Subject: Carlsbad Field Office Class 1 Permit Modification Notifications to the Waste Isolation Pilot Plant Hazardous Waste Facility Permit Number: NM4890139088-TSDF

**Class 1 Permit Modification Notifications**

**Update Property Protection Area Fence Line to Incorporate Temporary Fence Changes and Update WIPP Emergency Evacuation Figures and Text**

**Waste Isolation Pilot Plant  
Carlsbad, New Mexico**

Figure A4-2-NFB  
 WIPP Traffic Flow Diagram with Building 416

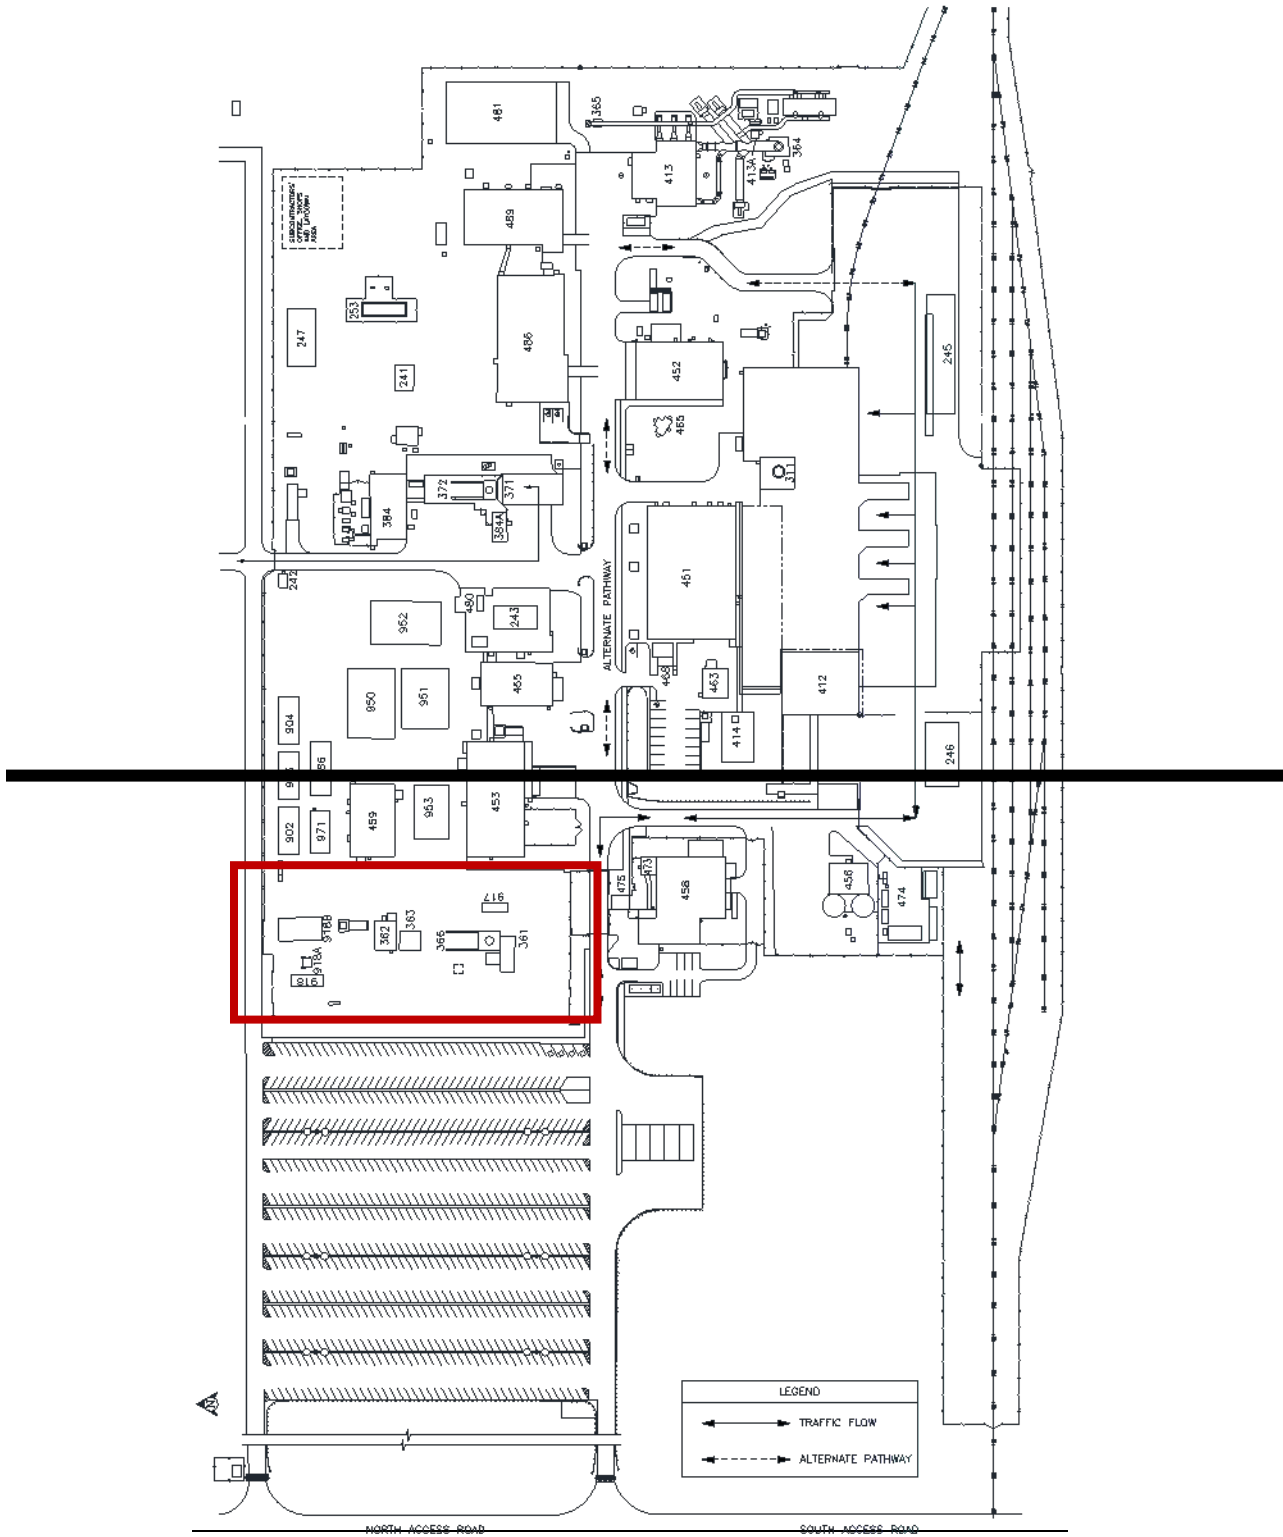
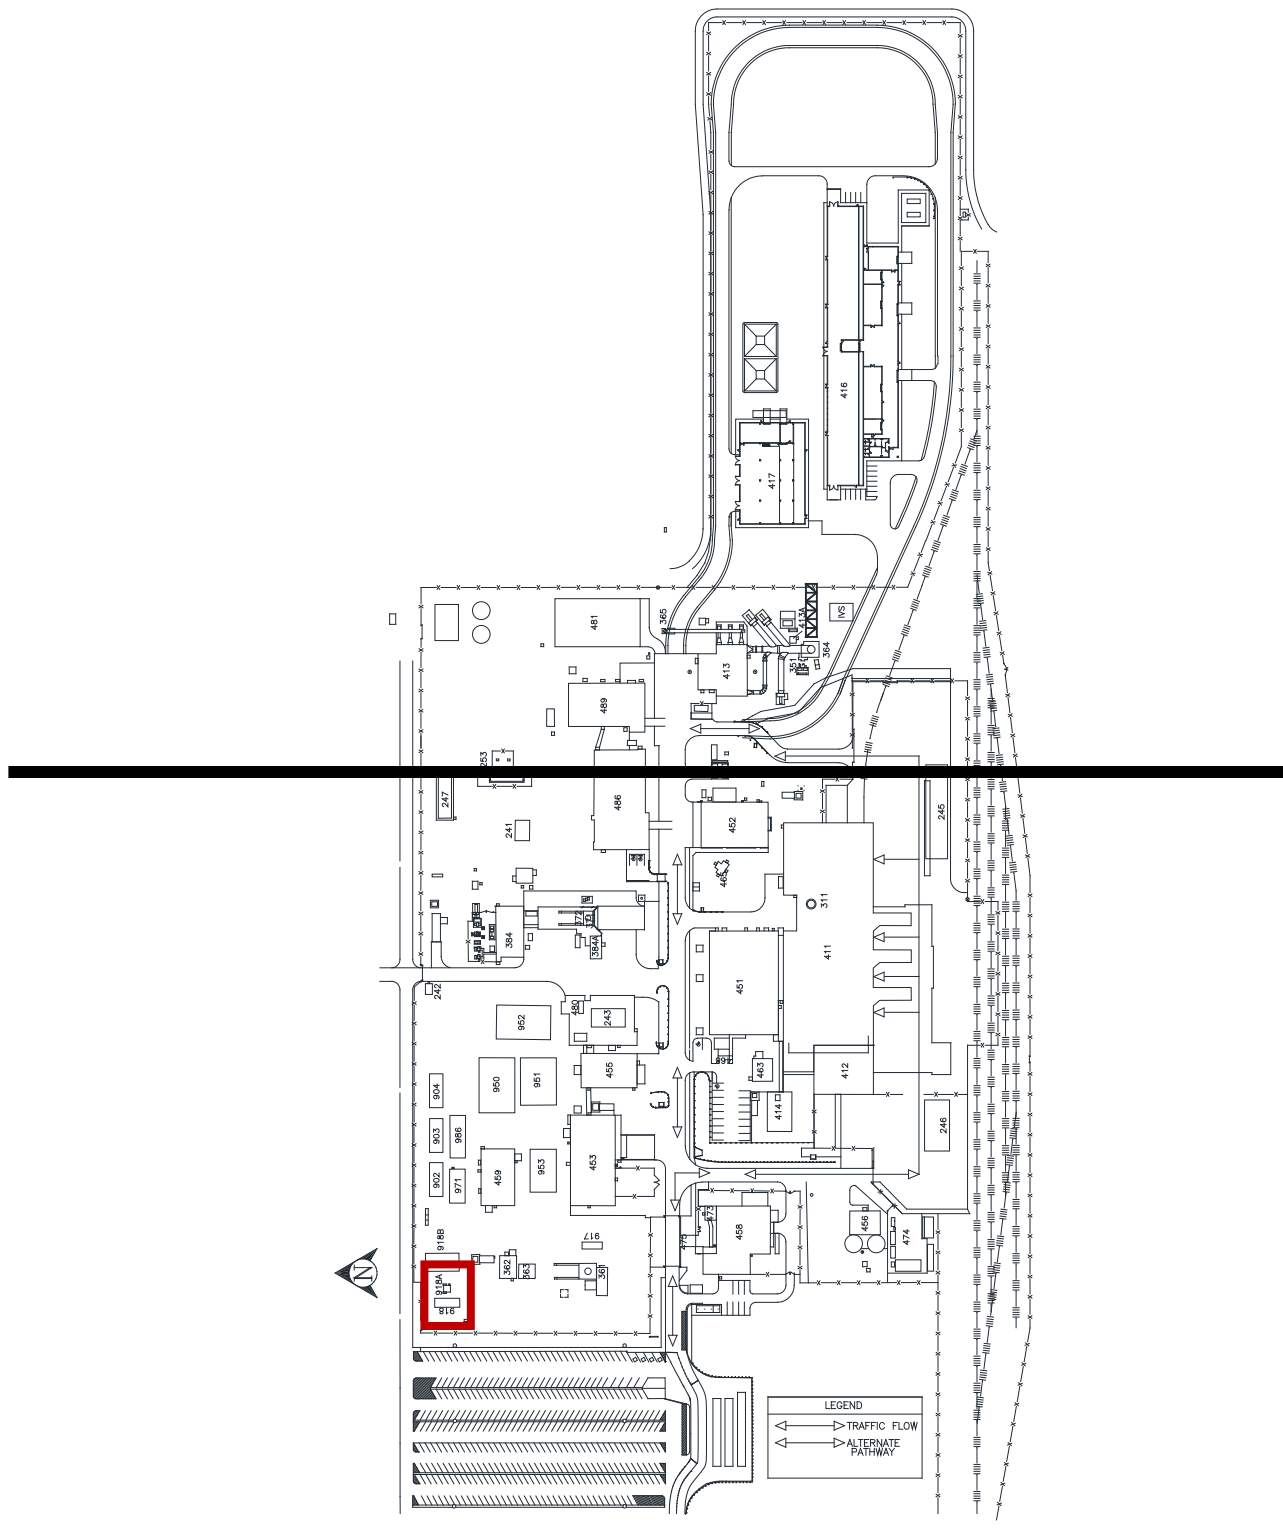
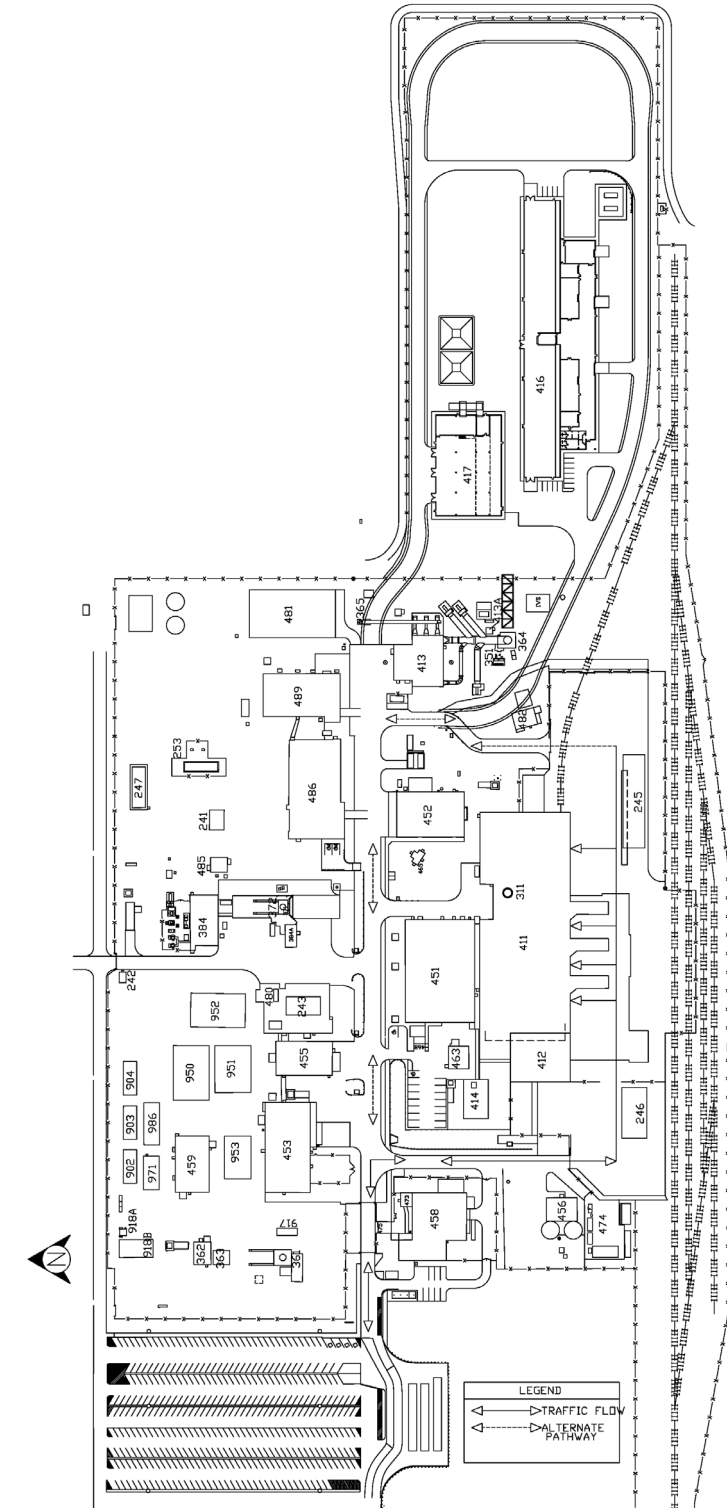
- Attachment A4, Figure A4-2, *WIPP Traffic Flow Diagram*
- Attachment A4, Figure A4-2-NFB, *WIPP Traffic Flow Diagram with Building 416*
- Attachment D, Figure D-1, *WIPP Surface Structures*
- Attachment D, Figure D-1a, *Legend to Figure D-1*
- Attachment D, Figure D-1-NFB, *WIPP Surface Structures with Building 416*
- Attachment D, Figure D-1a-NFB, *Legend to Figure D-1-NFB (Building 416)*

**Figure D-1**  
**WIPP Surface Structures**

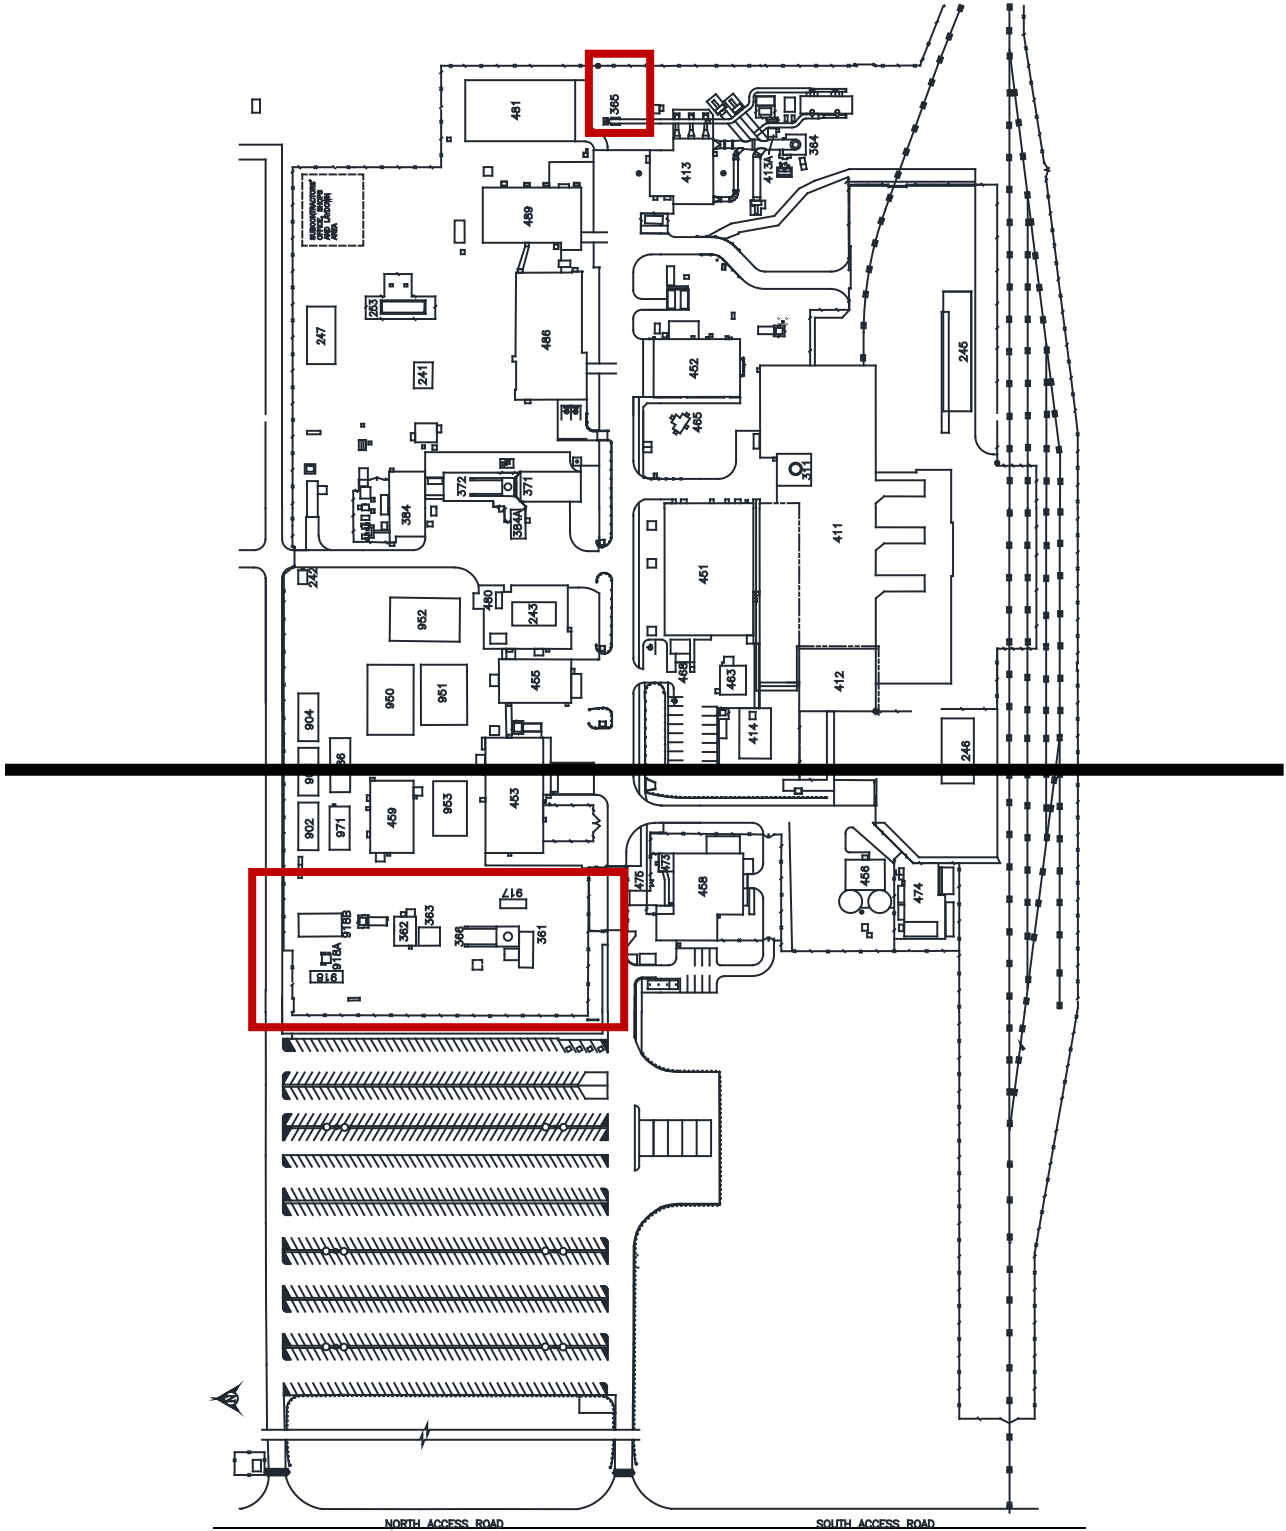
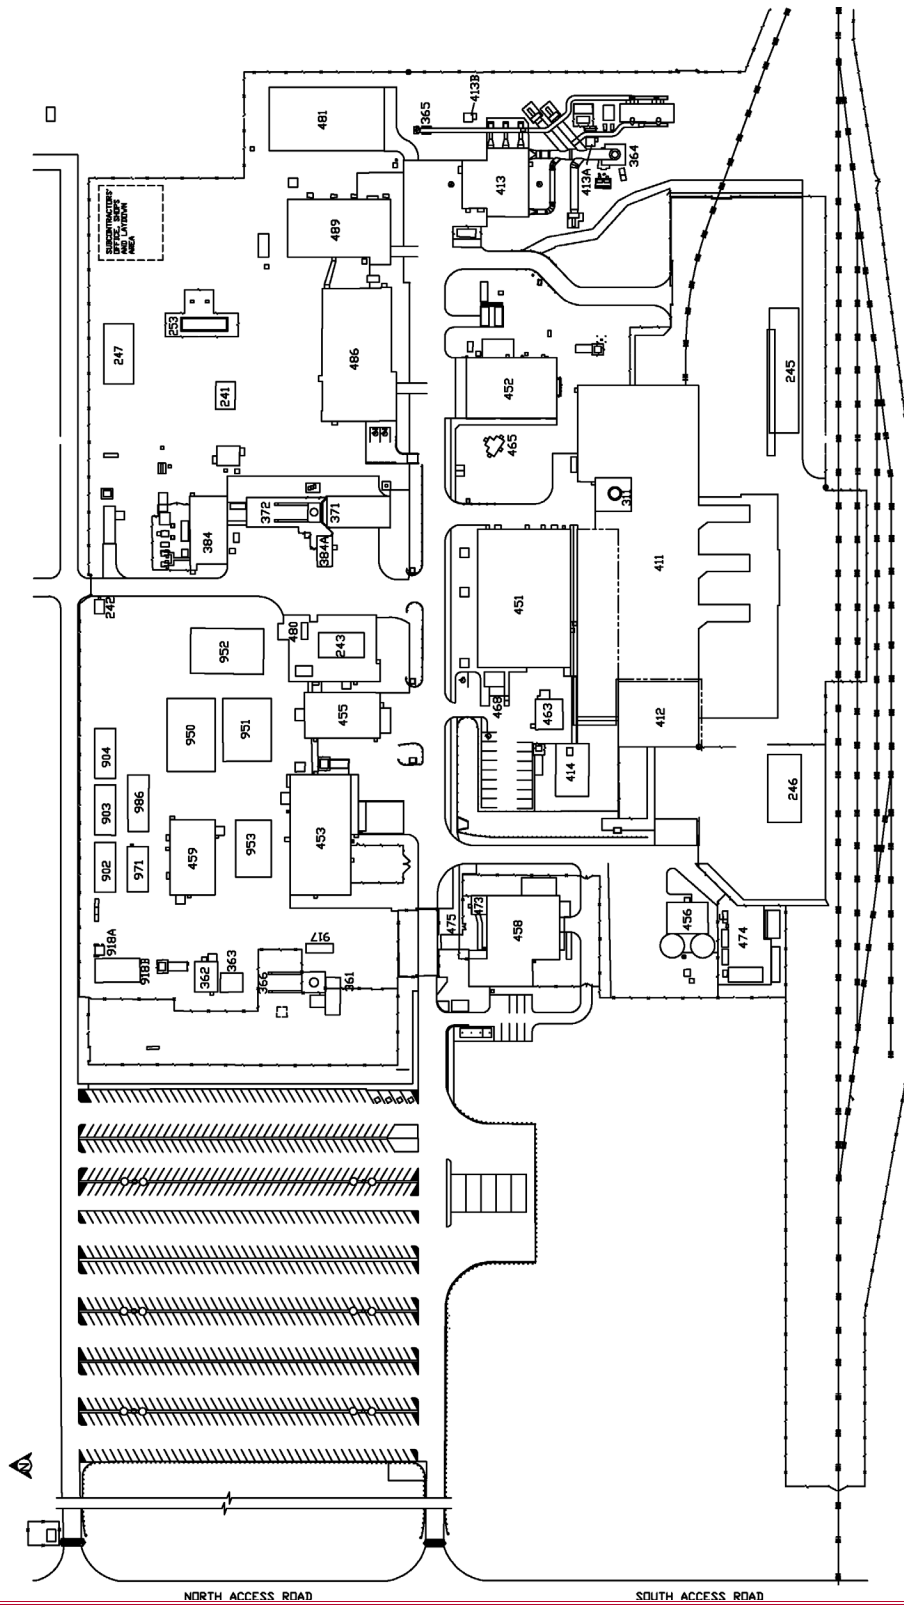
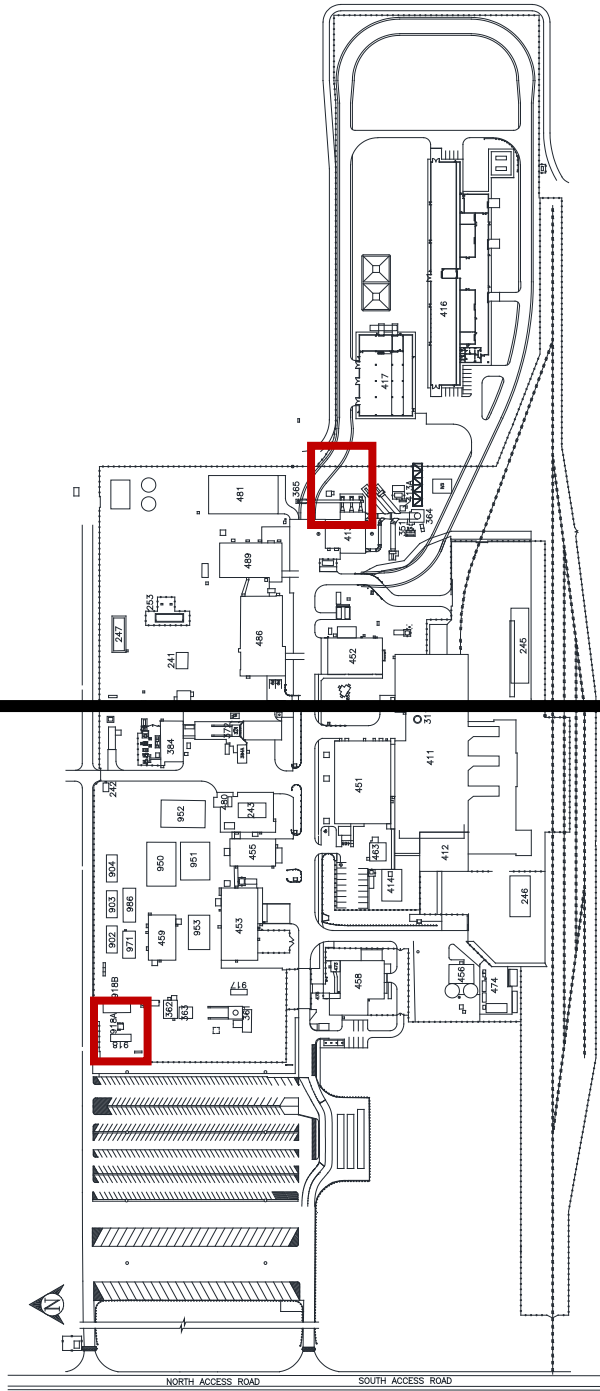
- Attachment D, Figure D-1, *WIPP Surface Structures*
- Attachment D, Figure D-1-NFB, *WIPP Surface Structures with Building 416*

In the process of constructing the temporary fence, Building 918A was relocated to the northeast corner of building 918B and Building 918 was removed. All figures depicting the overall site layout have been updated to incorporate the new location of Building 918A and the removal of Building 918 for completeness and accuracy of the Permit.

Figures D-1 and D-1-NFB have also been updated to incorporate the labeling of Building 413B for completeness and alignment with the respective figure legends, Figures D-1a and D-1a-NFB. These changes are needed to ensure completeness and accuracy of the Permit.
